RE: Appolo Fuels, Inc.
Permit No. 807-0368, Original

In response to your third technical review letter dated September 8, 2009, we have made the following corrections to the above referenced application.

In response to your third technical review letter dated August 19, 2009, we have made the following corrections to the above referenced application.

In response to your second technical review letter dated July 23, 2009, we have made the following corrections to the above referenced application.

Appolo Fuels, Inc. Permit #807-0368 Additional Cross-Sections Near Hollow Fill #1 Attachment 25.1.A		Scale: 1" = 100'
		 <small>Howard Engineering and Surveying, Inc. 9300 Hwy 271, Suite 1100, Knoxville, TN 37921 865-594-1491 / www.howardeng.com</small>

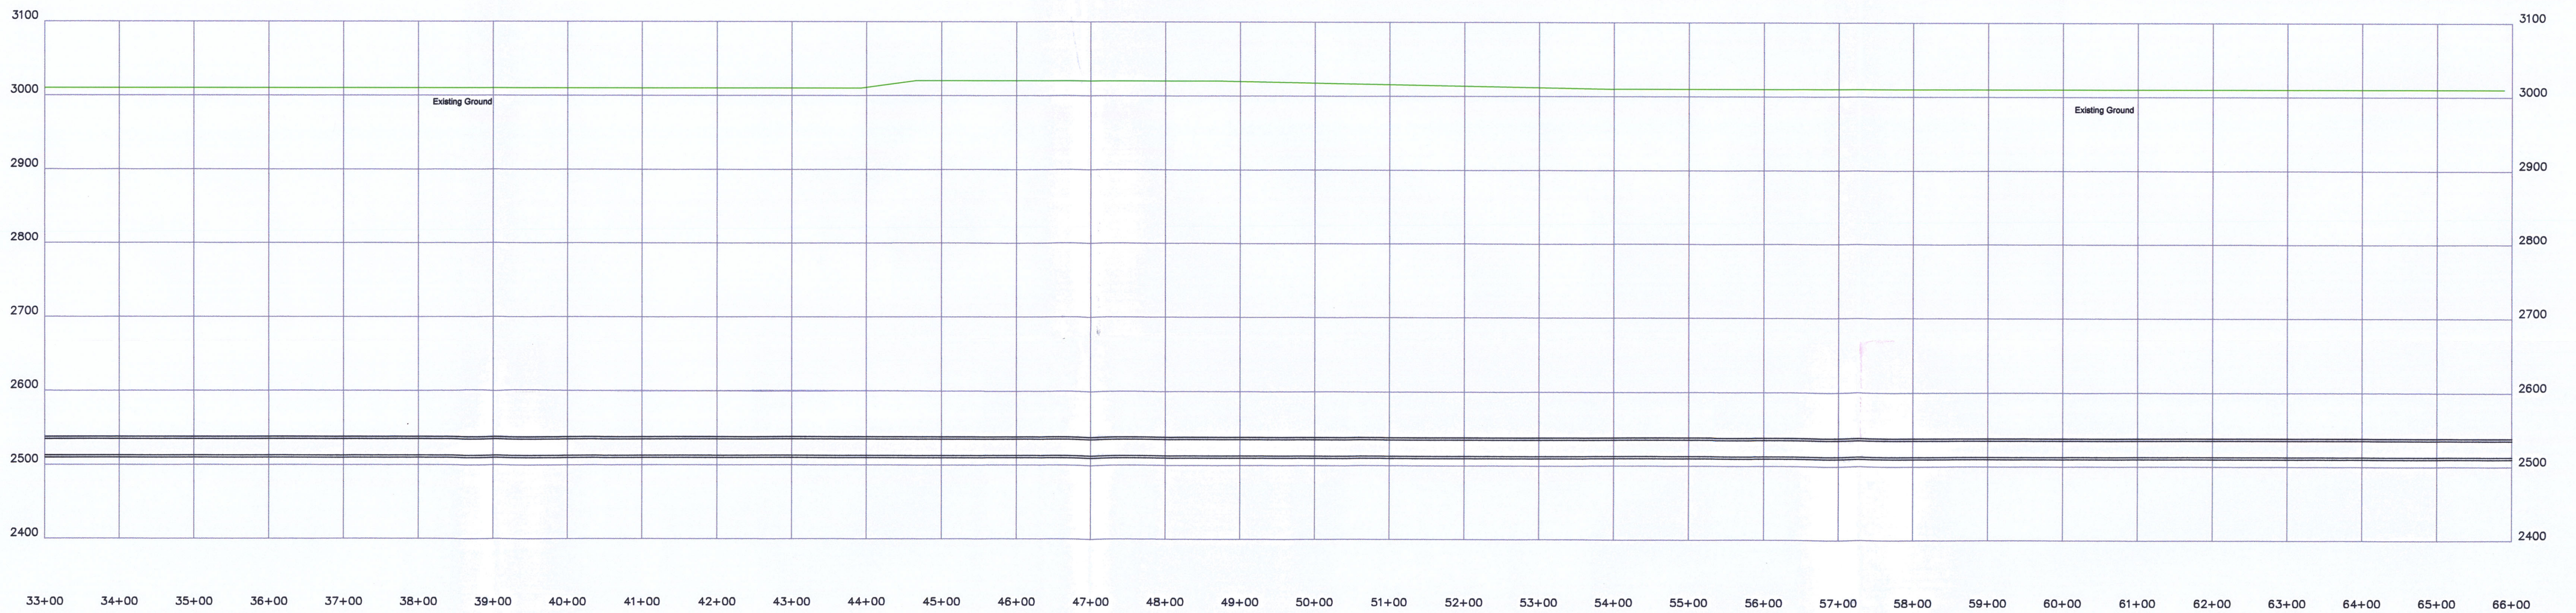
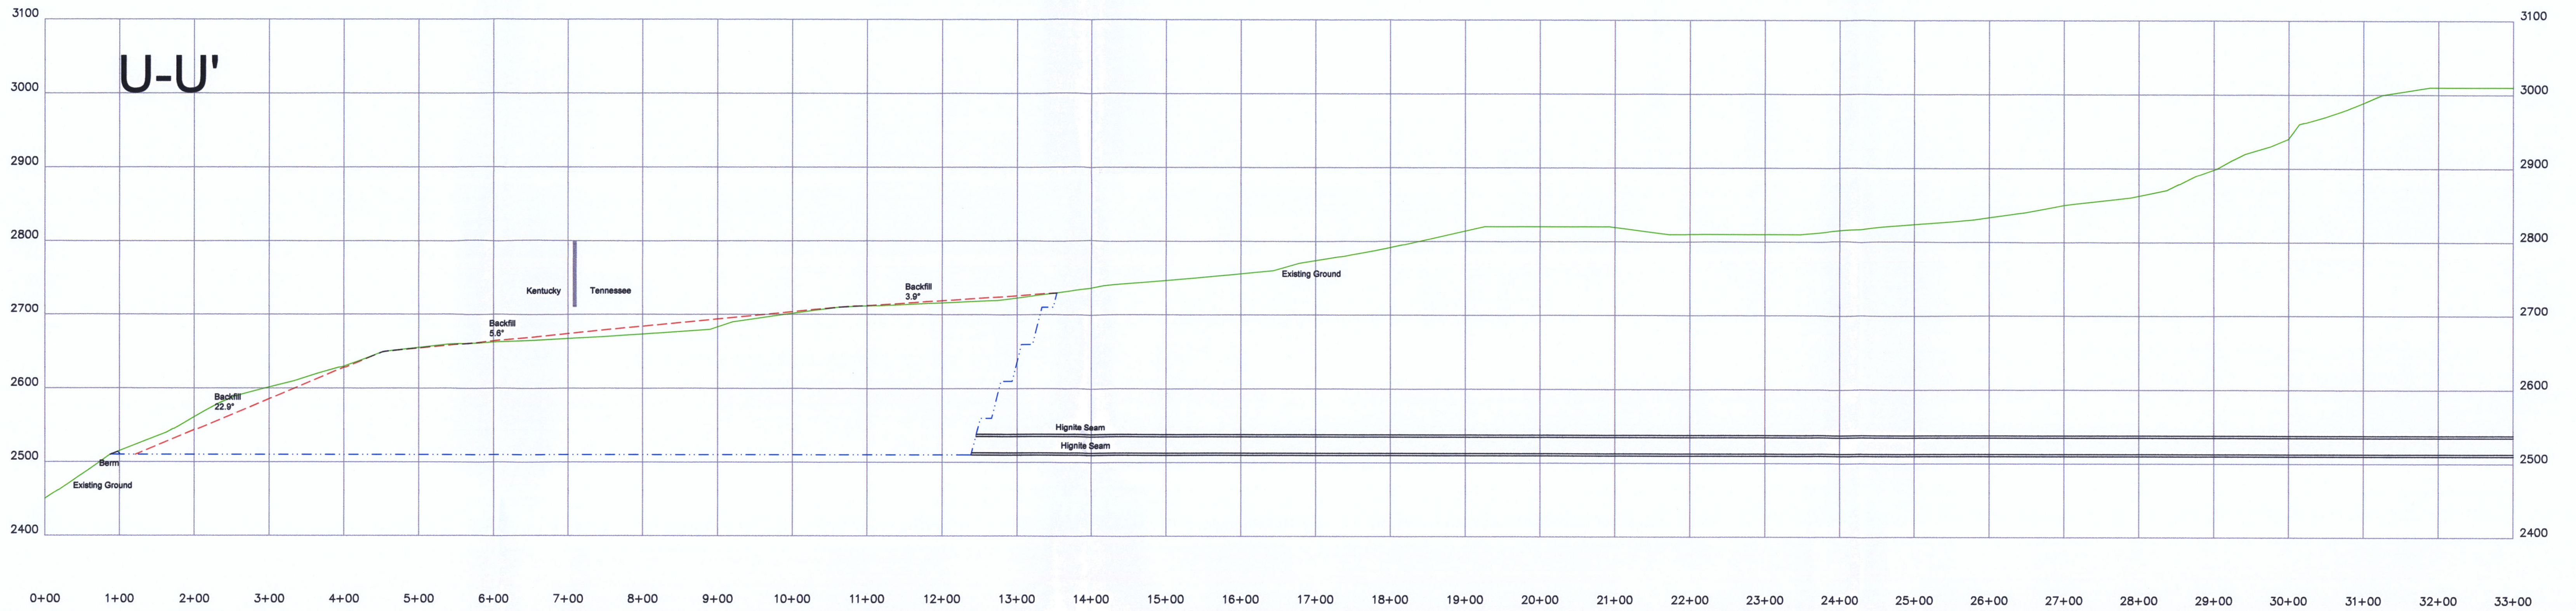
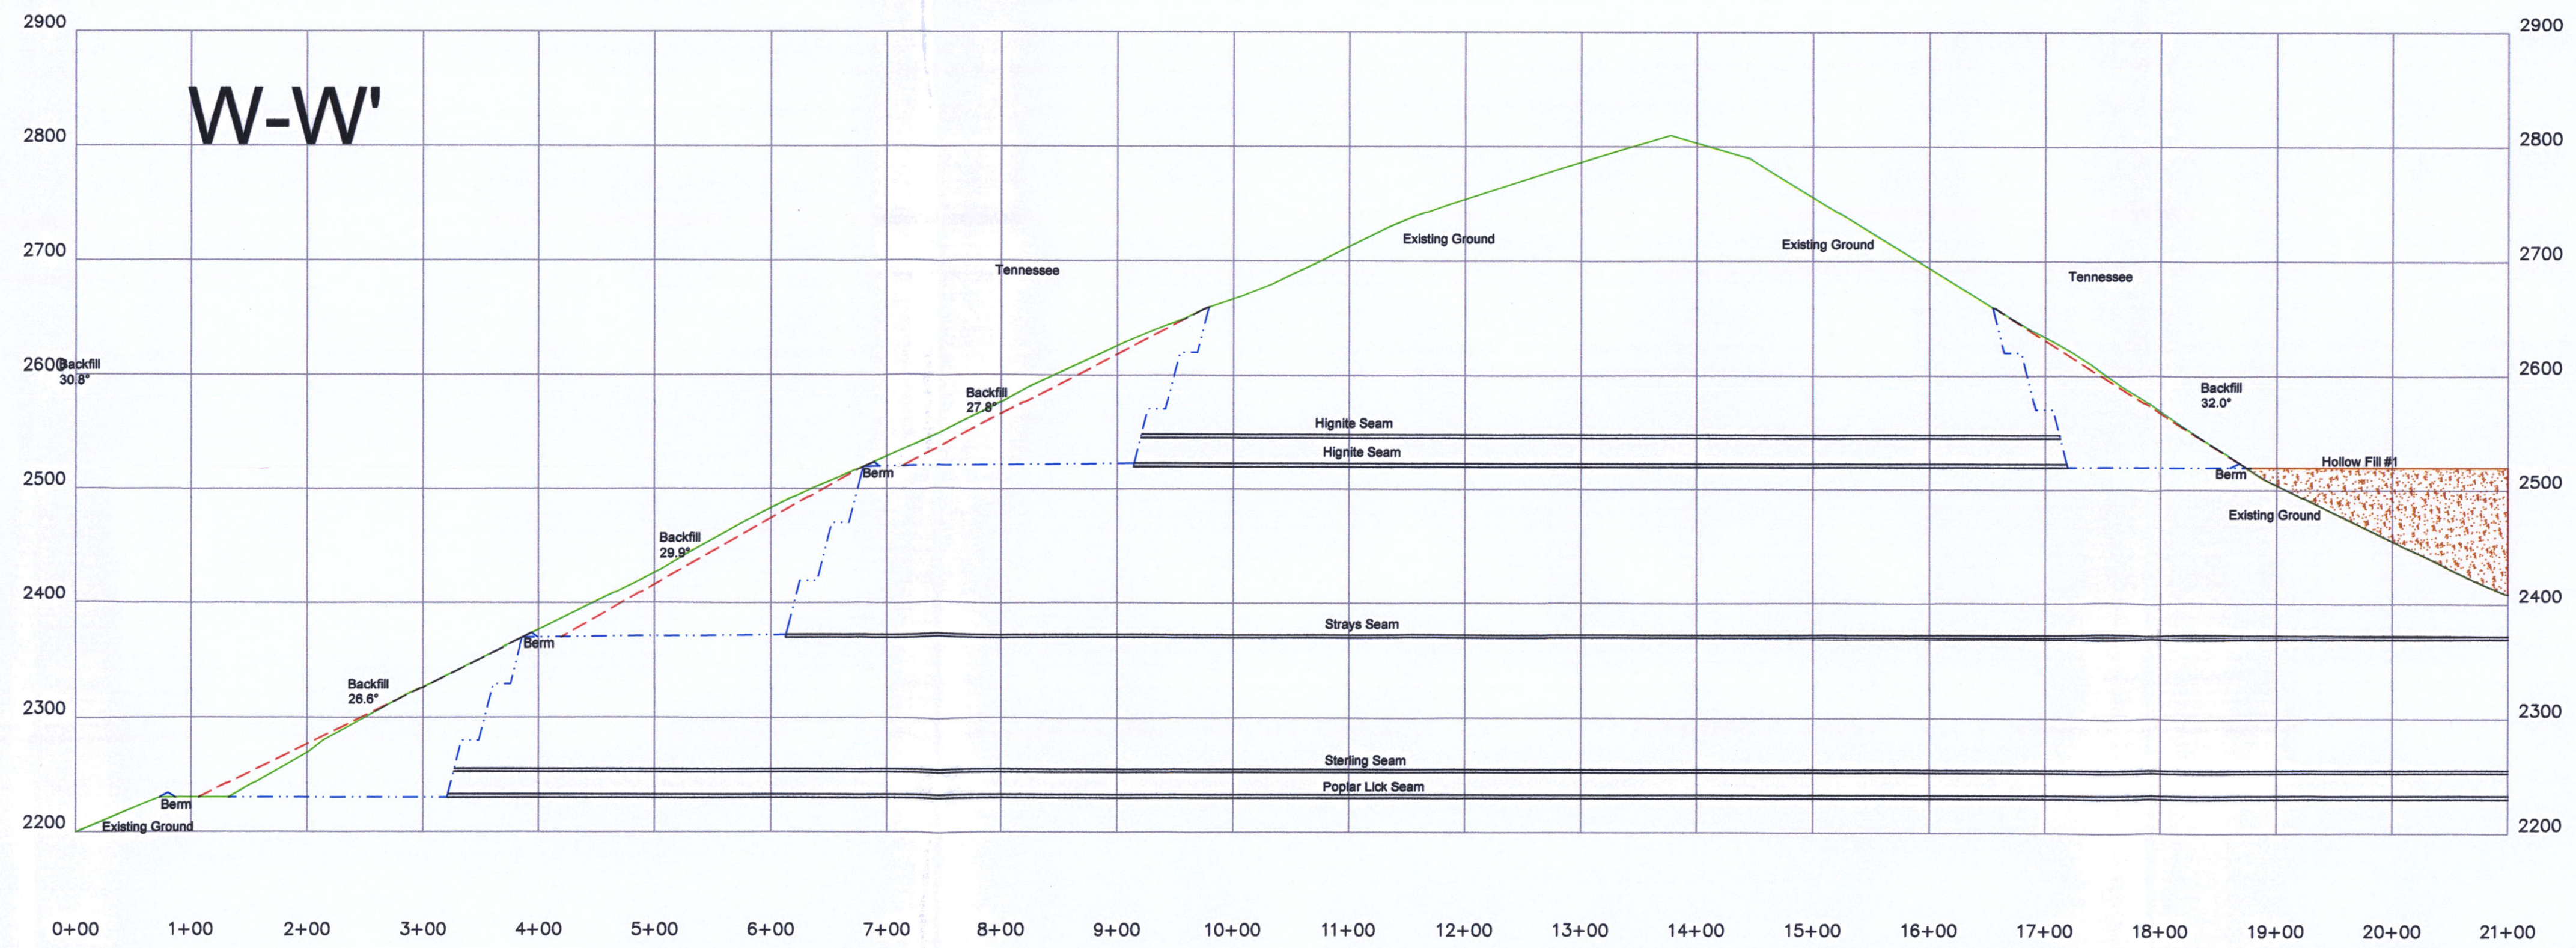
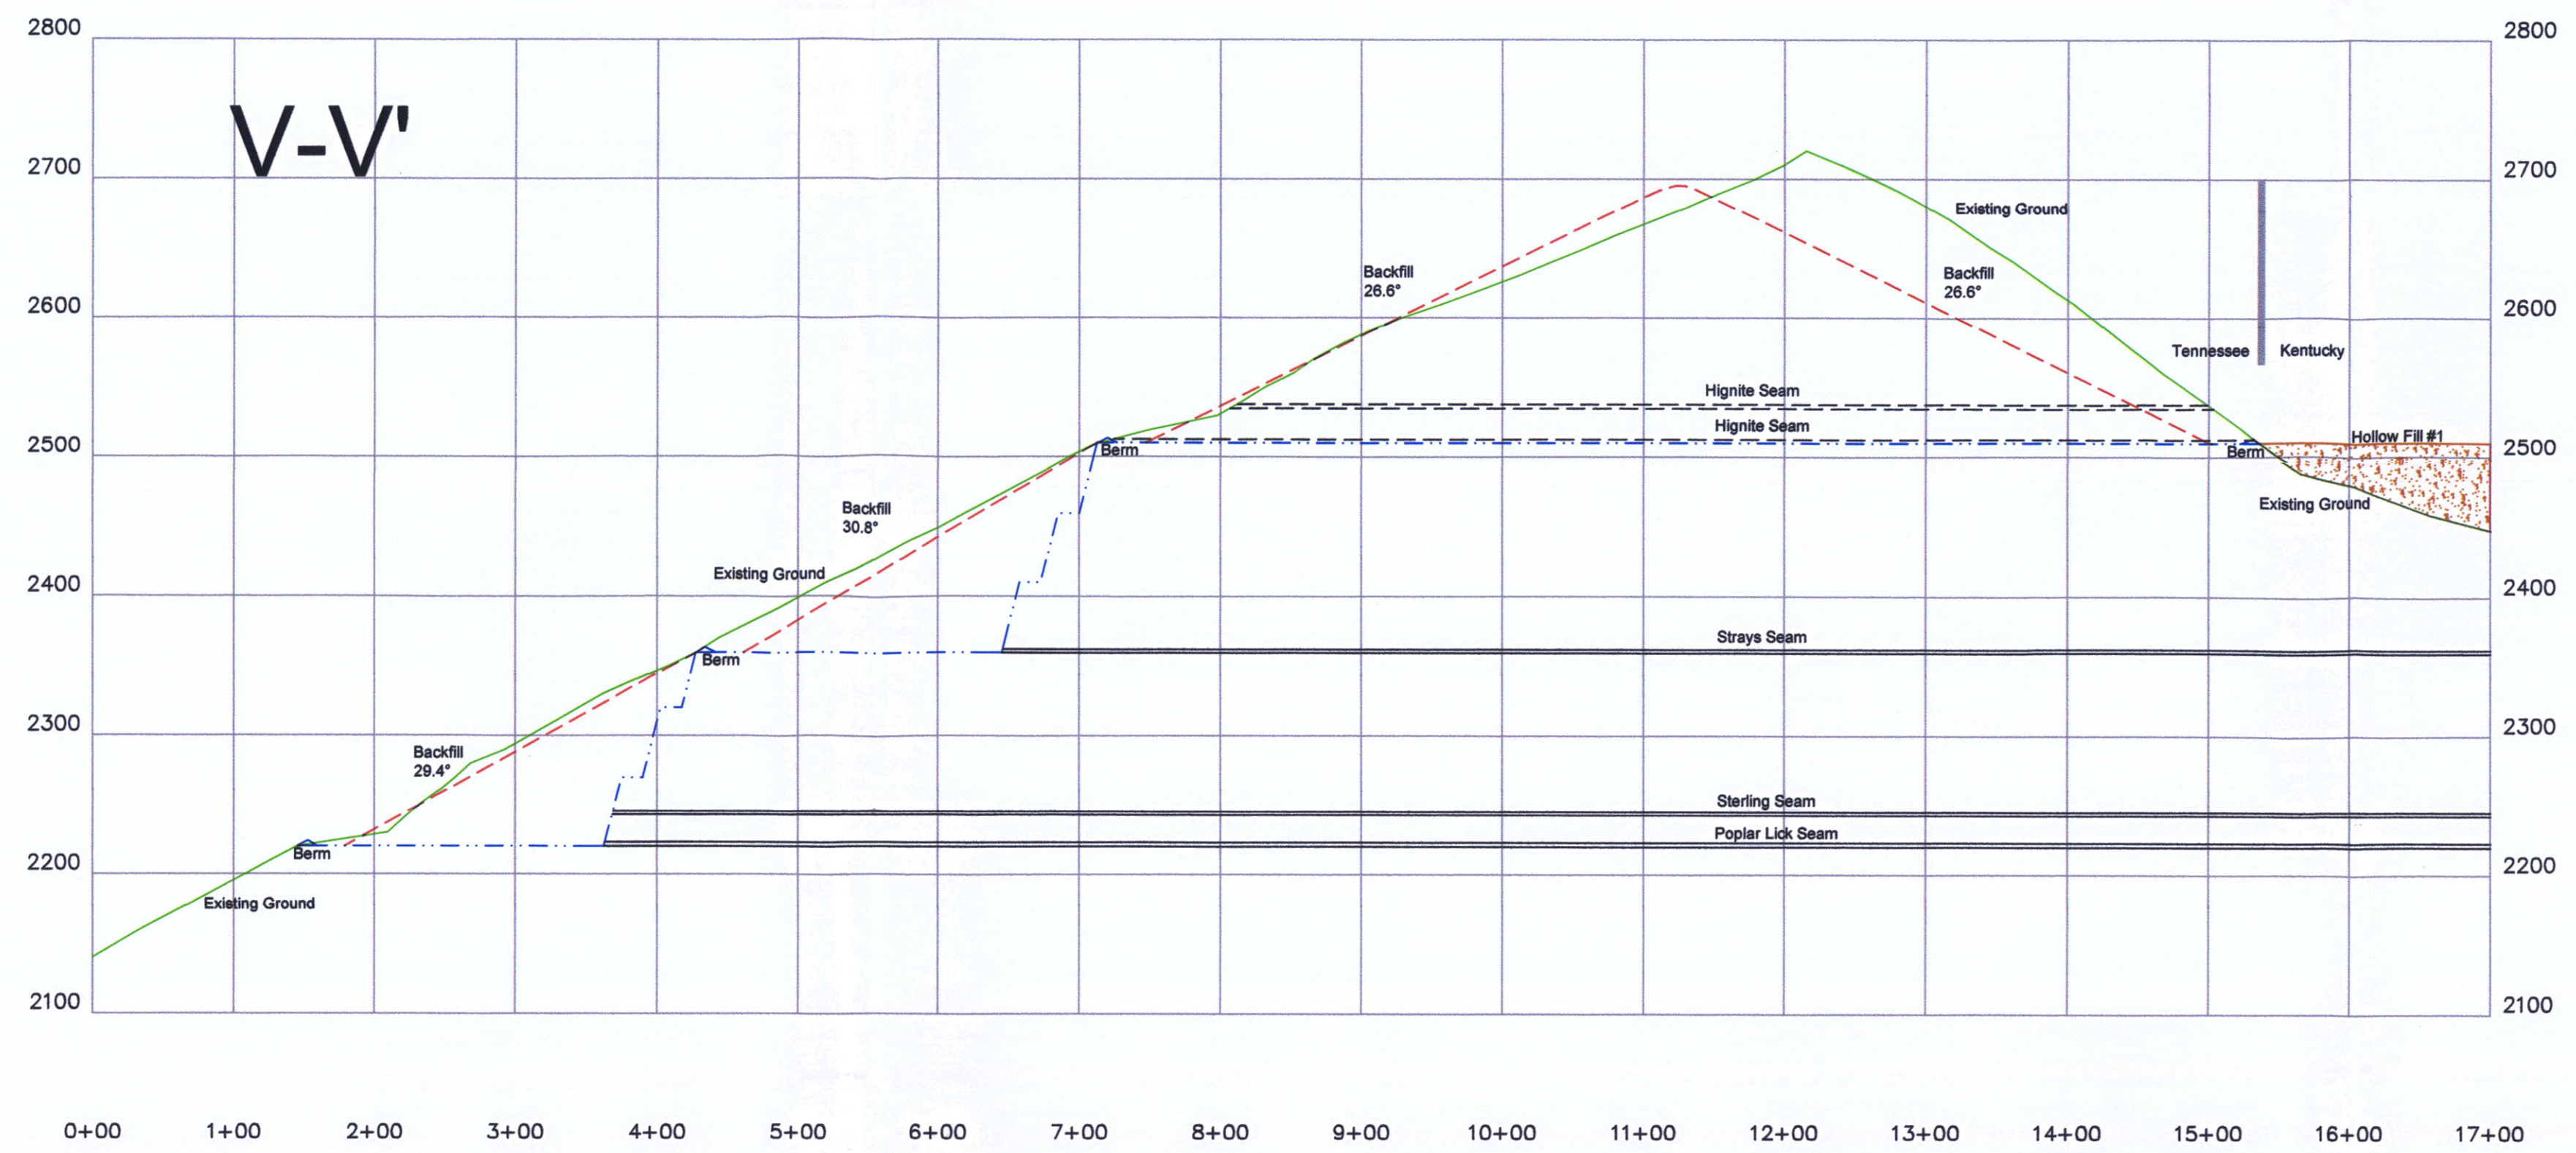
11. Item 25. – Engineering Compliance Review (Additional Cross-sections): A portion of the watershed that contributes to HF-1’s drainage is in Tennessee; show additional cross-sections along the ridges (and perpendicular to them); hence, one is aware of the changes in the postmining topography that contributes to HF-1 drainage.
